Input Data

Plan Amendment

Figure 1: Added lanes between version 8.3 and 8.3.1.

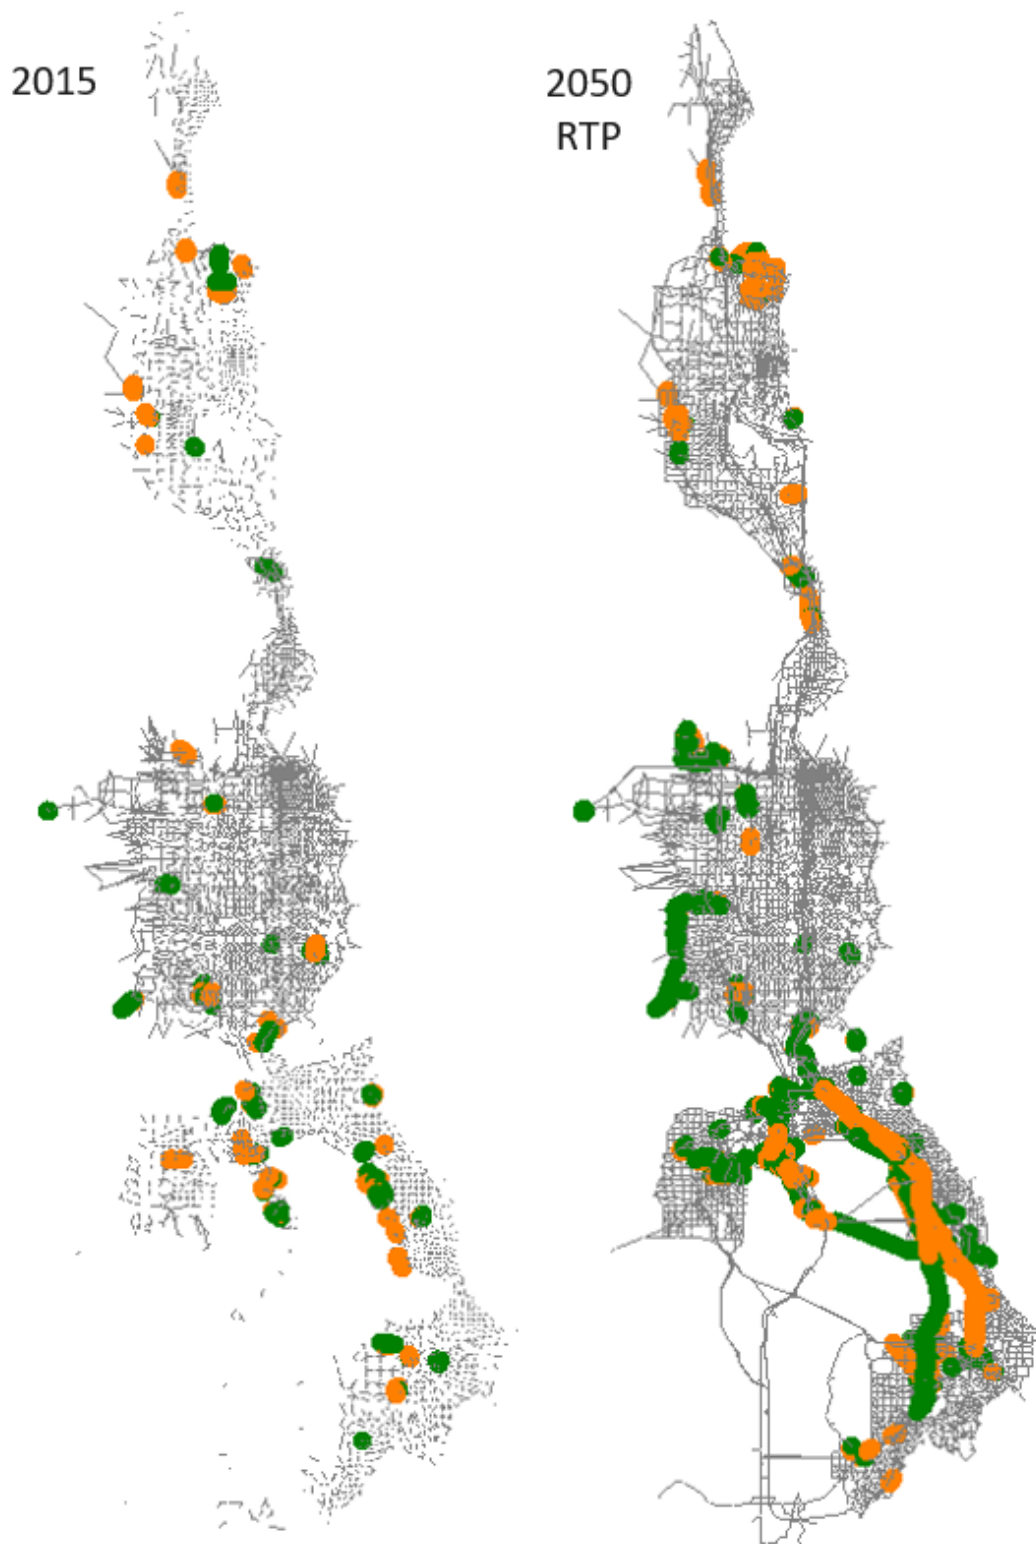
The highway network was updated in the MAG and WFRC areas to reflect the first round of Regional Transportation Plan (RTP) amendments. Additional edits were made in the MAG area to conform with more recent project clarification. The changes to the input highway network are significant, particularly in Utah County, and would most likely affect the travel model's output. Projects in and around areas of high change may want to do sensitivity tests to better understand the impact that these input network changes may have had on project-level decisions. Figure 1 shows where lanes were added (green) or were taken away (orange) between versions 8.3 and 8.3.1 highway networks.

Figure 1: SR 201 connection externals.

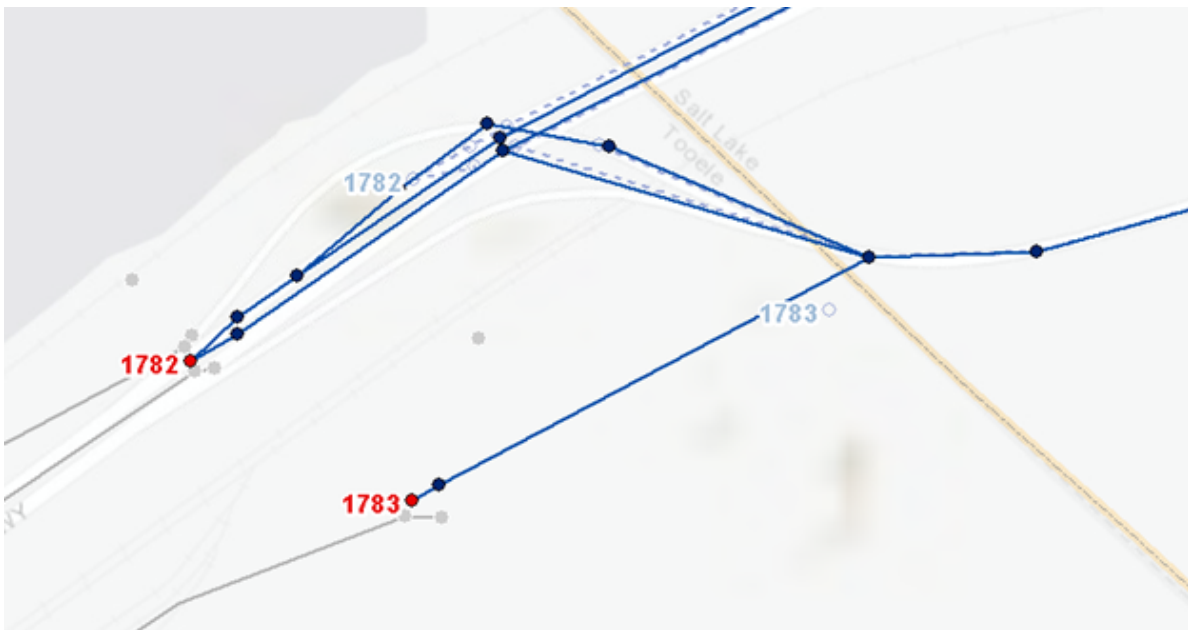
The highway network was modified at the Salt Lake, Tooele County boundary to provide an independent connection to SR 201 at external 1783. (Note external 1783 existed in the version 8.3 network as a place holder and was not connected to the network in that version.) Externals 1782 and 1783 were moved to improve the connection between the Wasatch Front and USTM travel models. The connecting highway links were also modified to accommodate this change.

External 1783 is connected to the highway network via a high-speed divided highway (FT=14) beginning in the 2030 fiscally-constrained plan year. In this year, external volume forecasts also begin for external 1783. Prior to 2030, external 1783 is unconnected to the scenario network and the external volume is zero.

Figure 2: Average weekday traffic volumes for externals 1782 and 1783.

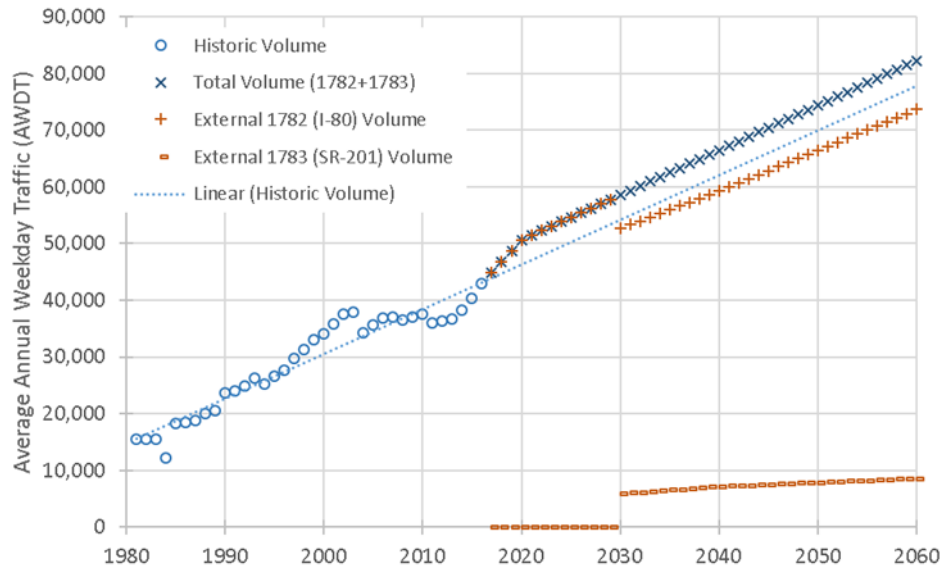
8.3 volume was then divided between the two externals based on information from the Utah Statewide Travel Model (USTM) and professional judgement. The average weekday, single-unit and combo-unit factors for external 1782 were brought up to date with the most current information from the master segment shapefile in the model input folder:

- Average Weekday Factor = 1.057 (was 0.980)
- Single-unit Truck Factor = 7.6% (13%)
- Combo-unit Truck Factor = 9.8% (was 10%)

While the forecast AADT is identical to version 8.3, the change in weekday factor increased the input volume into the Wasatch Front model space by roughly 6%. The relative share of these trips also changed with significantly fewer medium trucks and more passenger cars. The share of heavy trucks stayed about the same. The weekday and truck factors for external 1783 were set to be equal to external 1782.
